PROJECT
 P35B6 - EVANSTON K-4

TITLE
 OVERALL SITE PLAN

Proposed Changes:
 1. Moved building on-site ~2.5m closer to the western property line. Through detailed design development the building was shifted to accommodate better cut/fill and room for the potential future portables on the east of site. These portables are not in contract at this moment and would be added through a separate DP/BP in the future. Shifting the building accommodates future flexibility for this potential project.
 2. Deleted additional mechanical room. Through detailed design development the 2 original proposed mechanical rooms were consolidated into 1 mechanical room.

1 MECHANICAL ROOM ELEVATION - WEST
A301 1:100

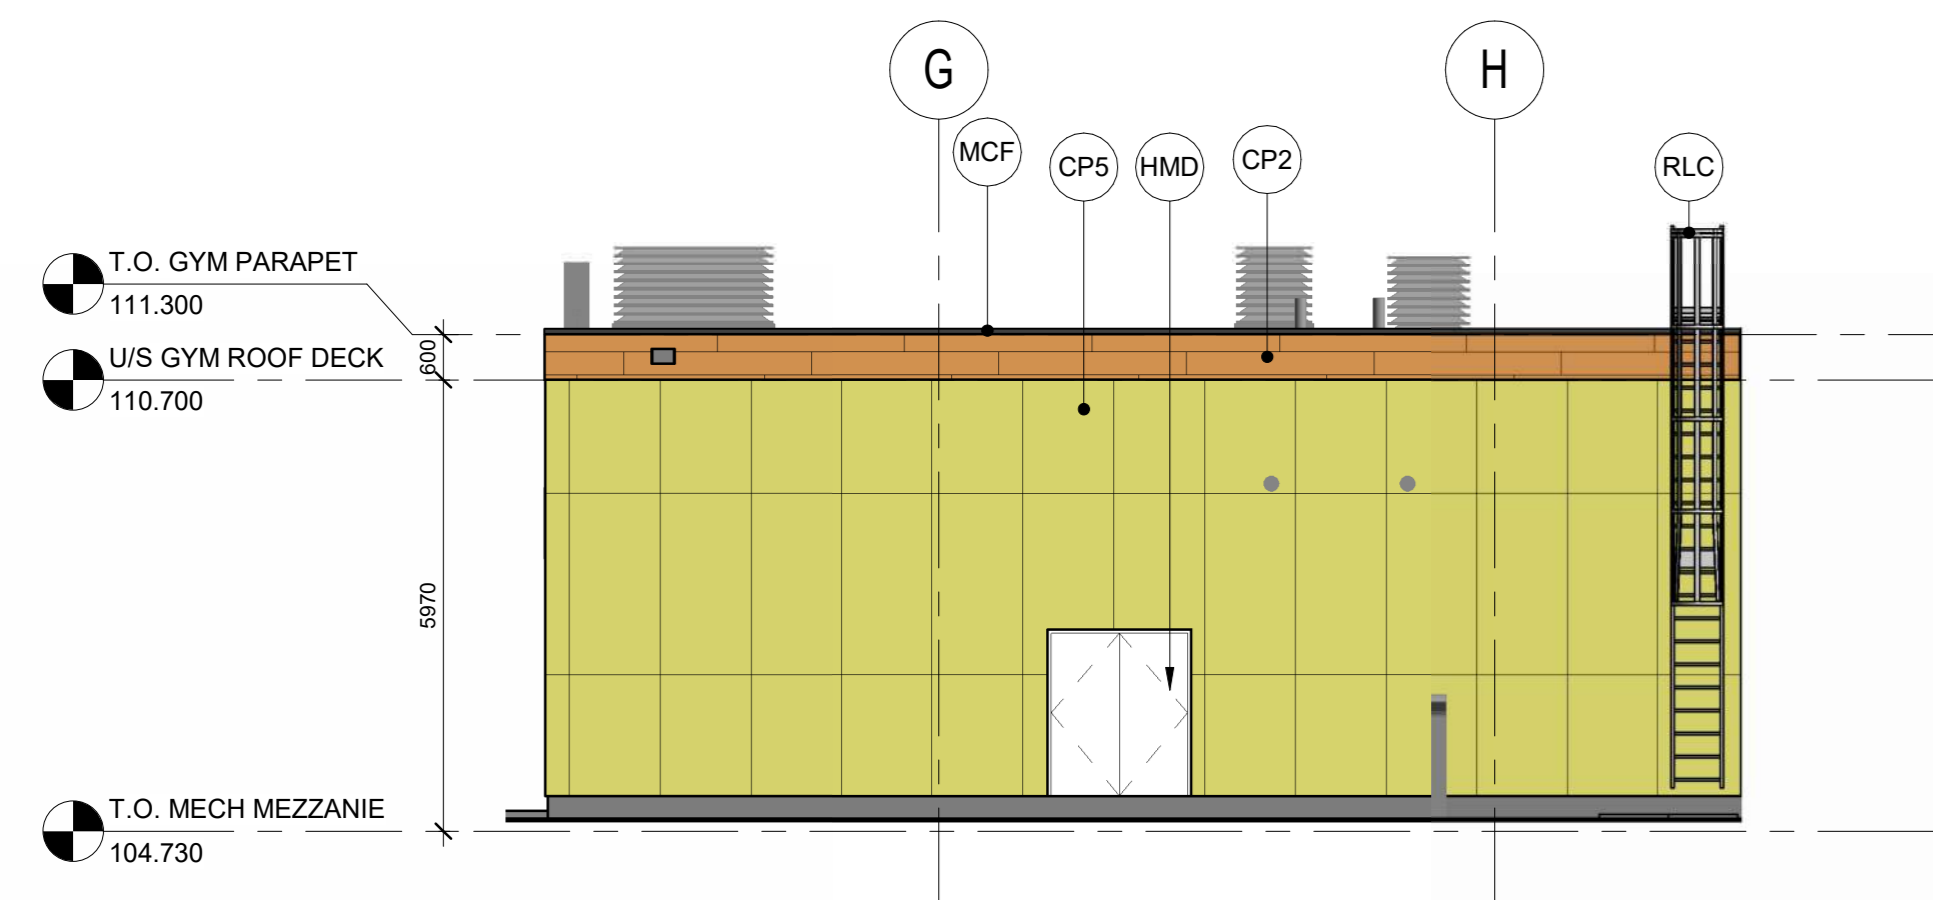
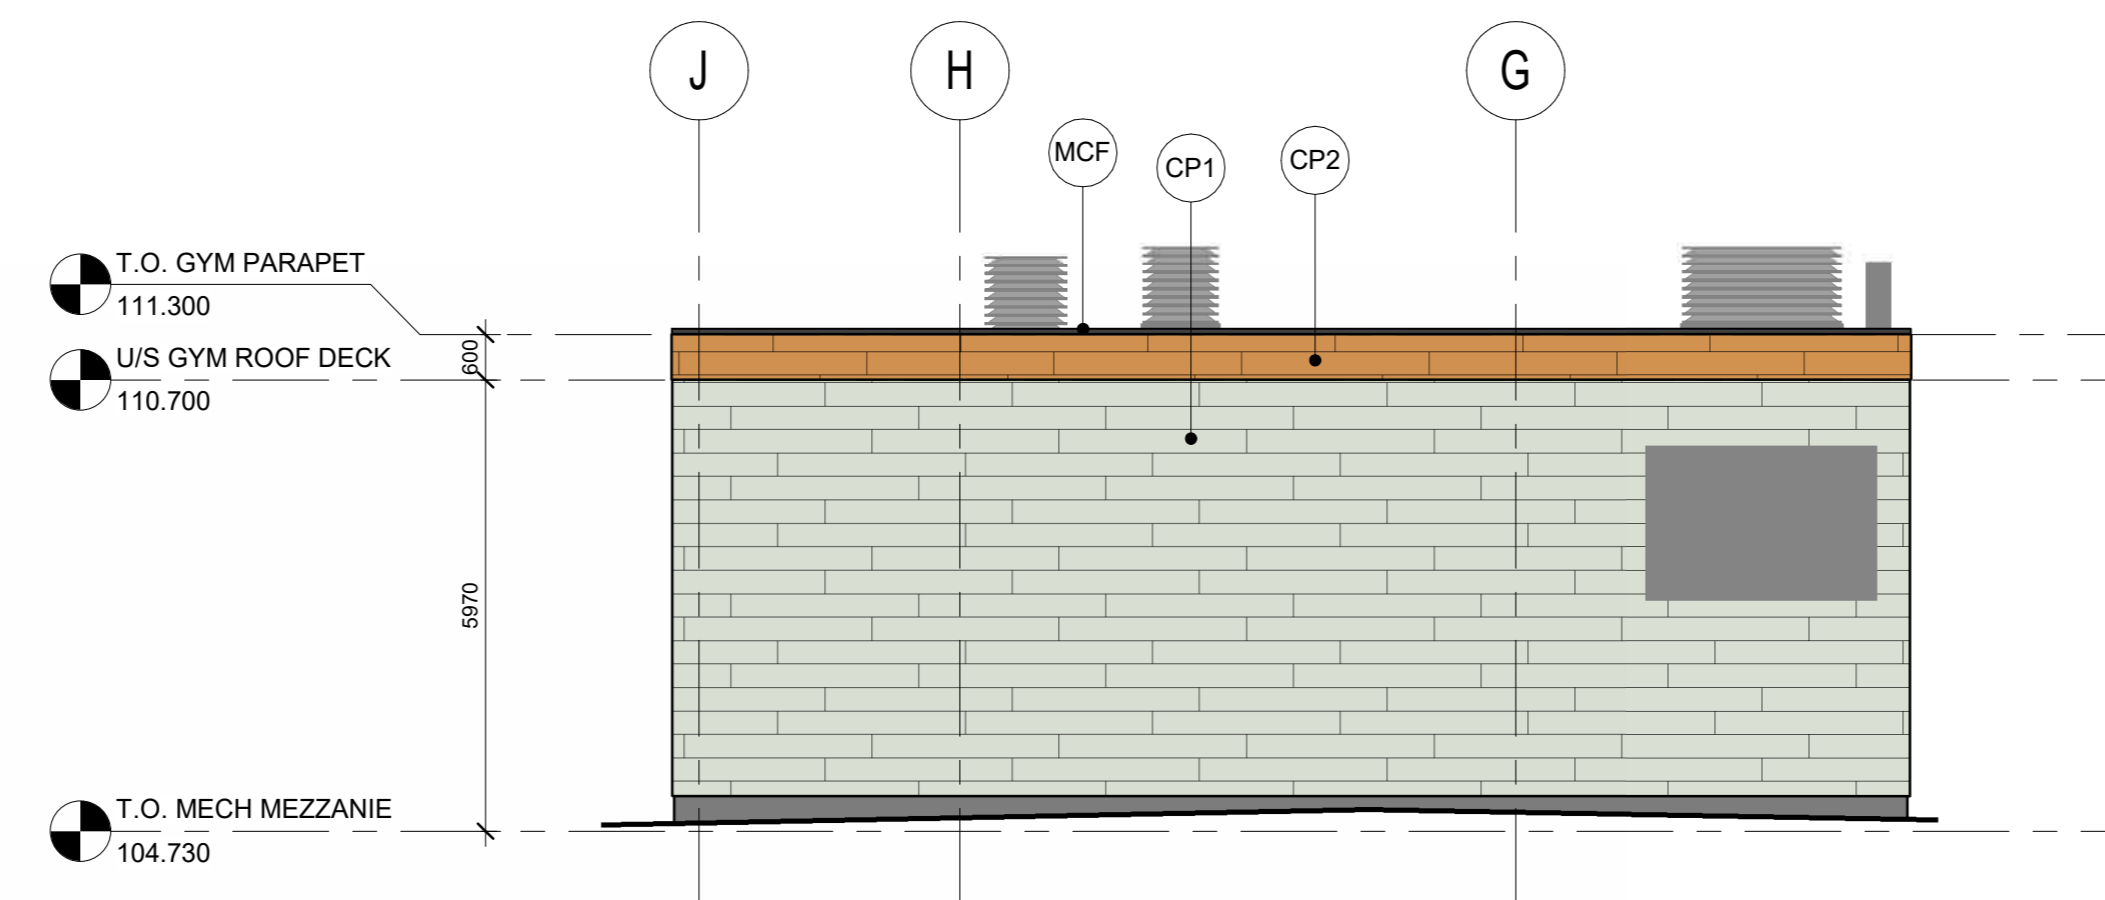
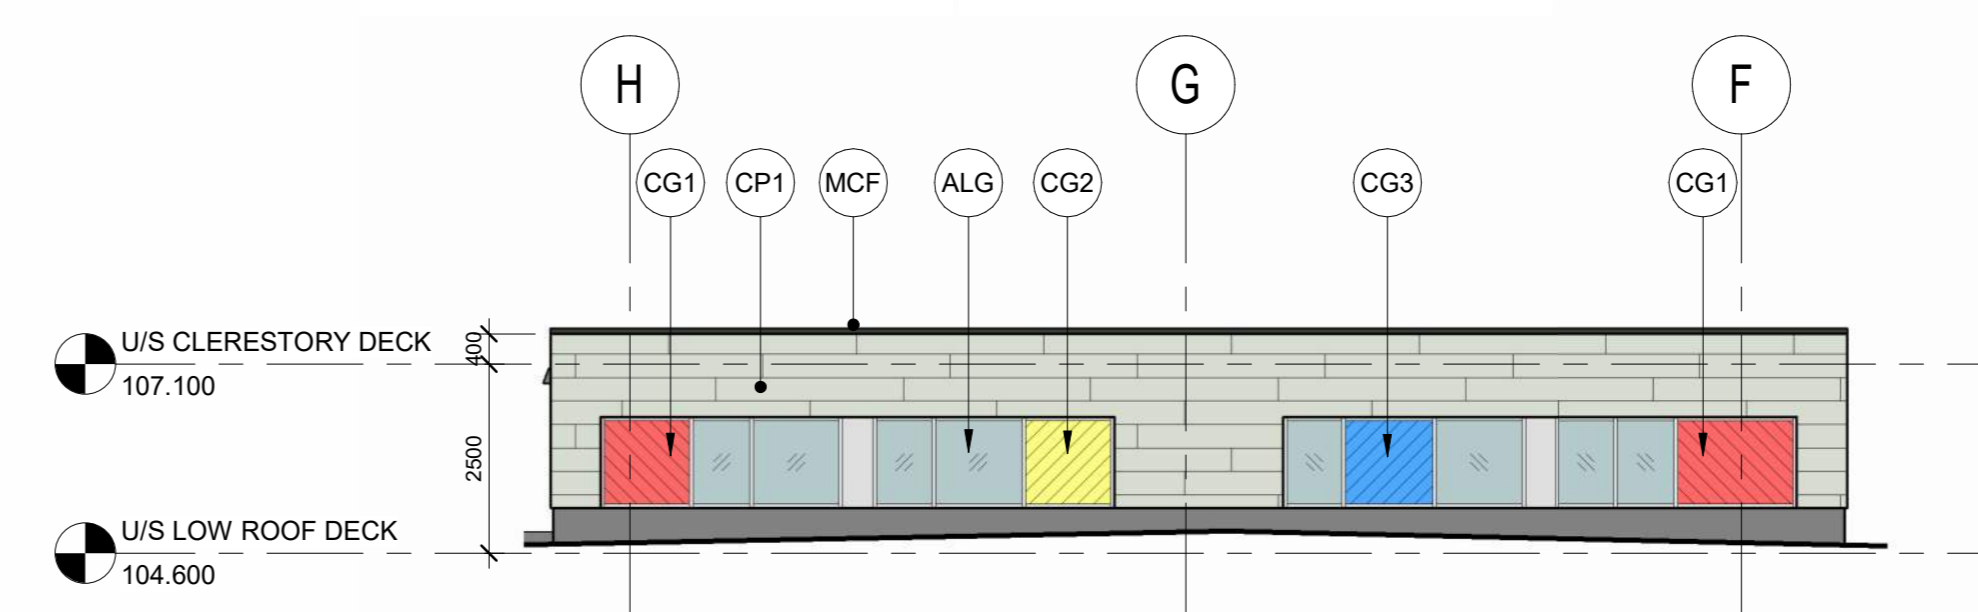
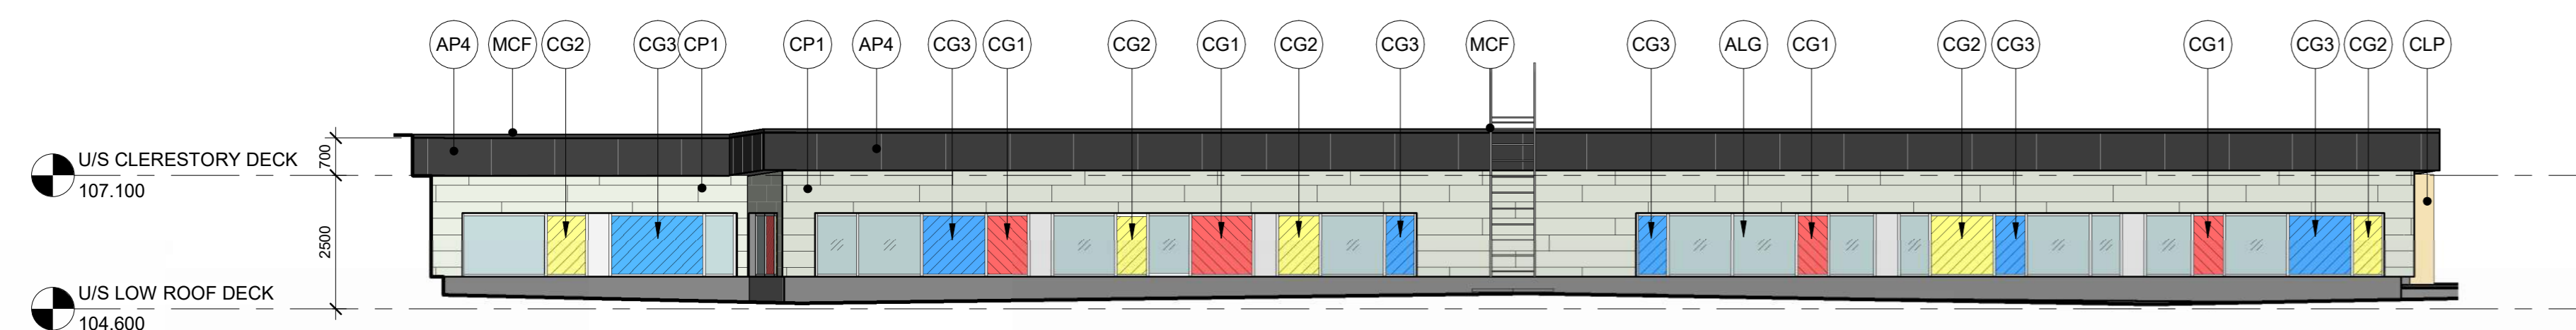
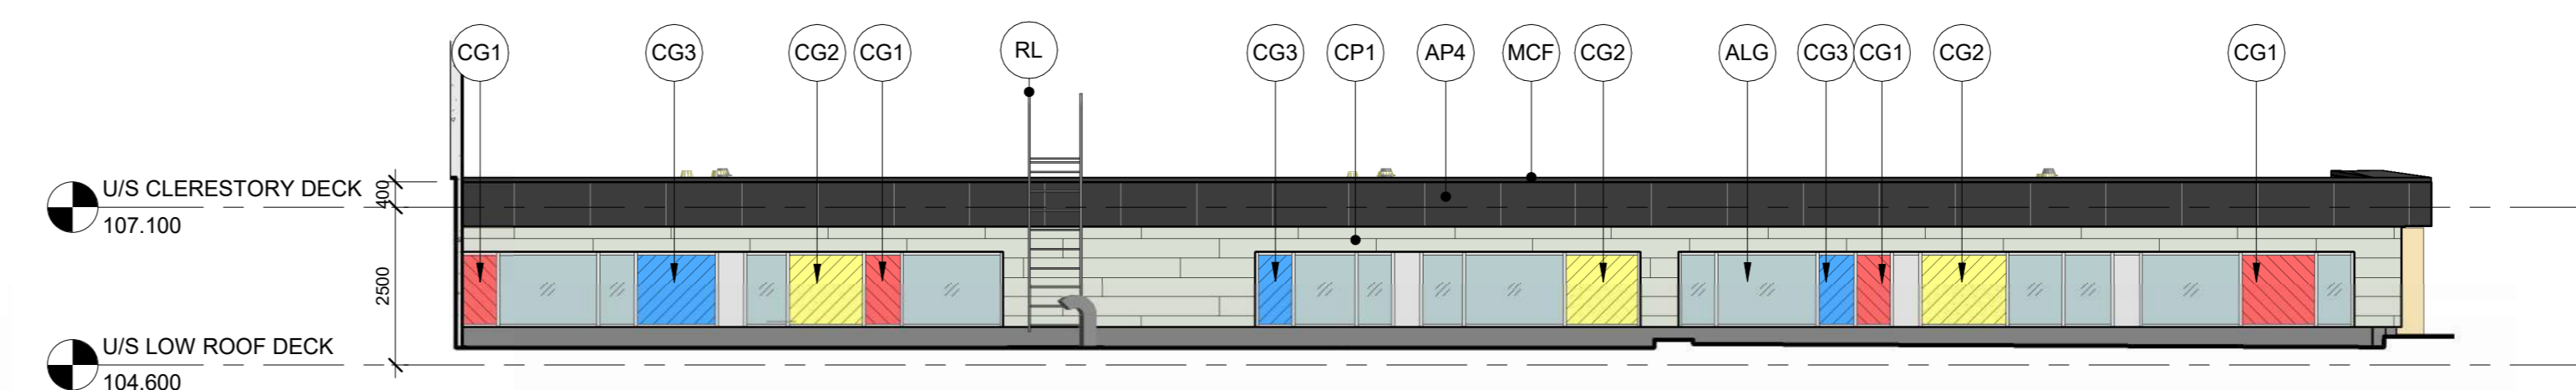
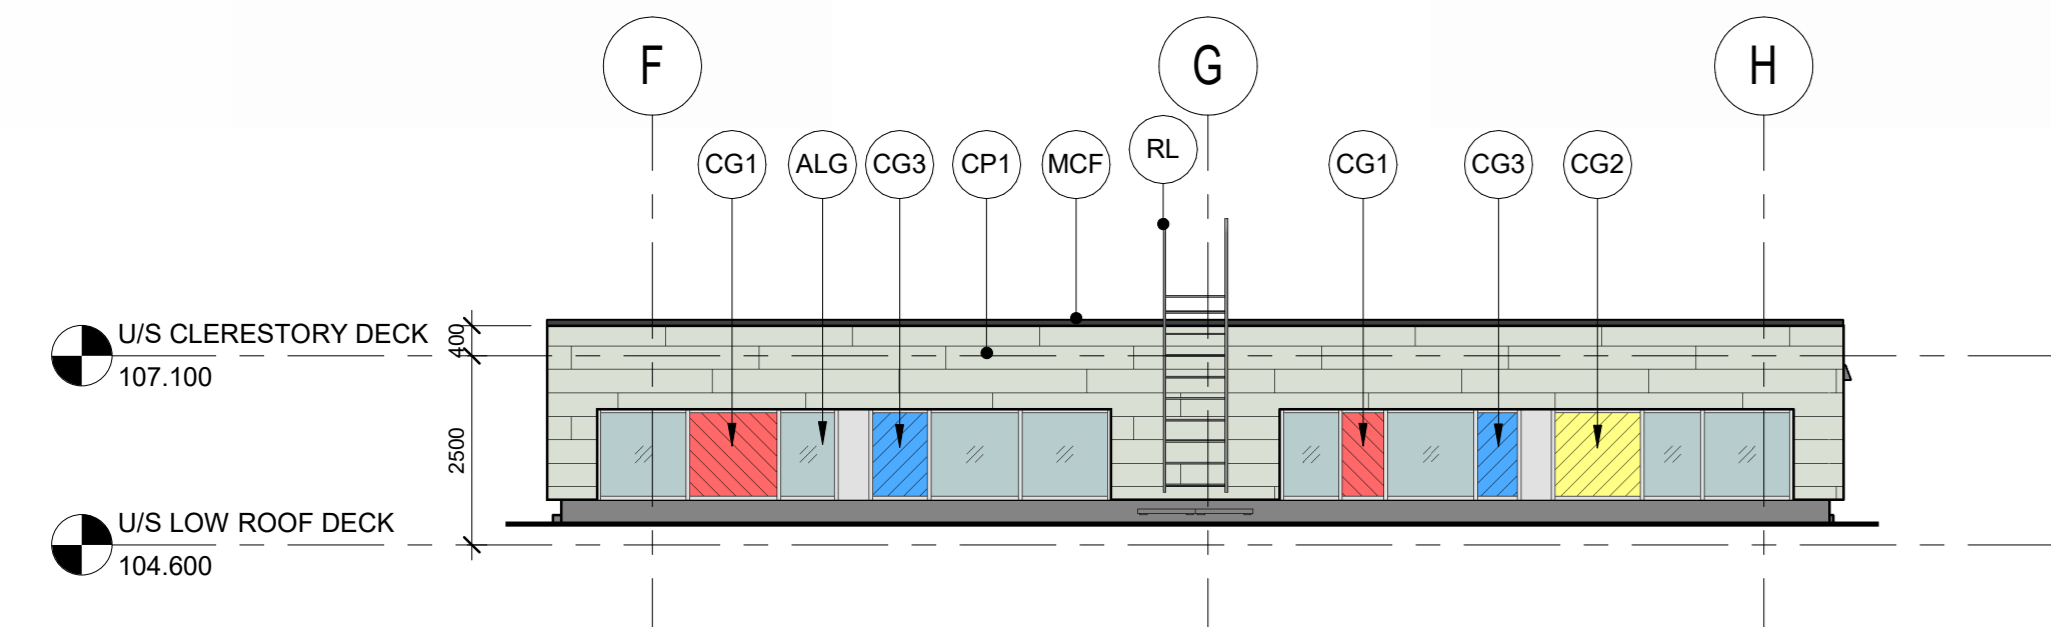
Proposed Changes:
 1. Moved building on-site ~2.5m closer to the western property line. Through detailed design development the building was shifted to accommodate better cut/fill and room for the potential future portables on the east of site. These portables are not in contract at this moment and would be added through a separate DP/BP in the future. Shifting the building accommodates future flexibility for this potential project.
 2. Deleted additional mechanical room. Through detailed design development the 2 original proposed mechanical rooms were consolidated into 1 mechanical room.
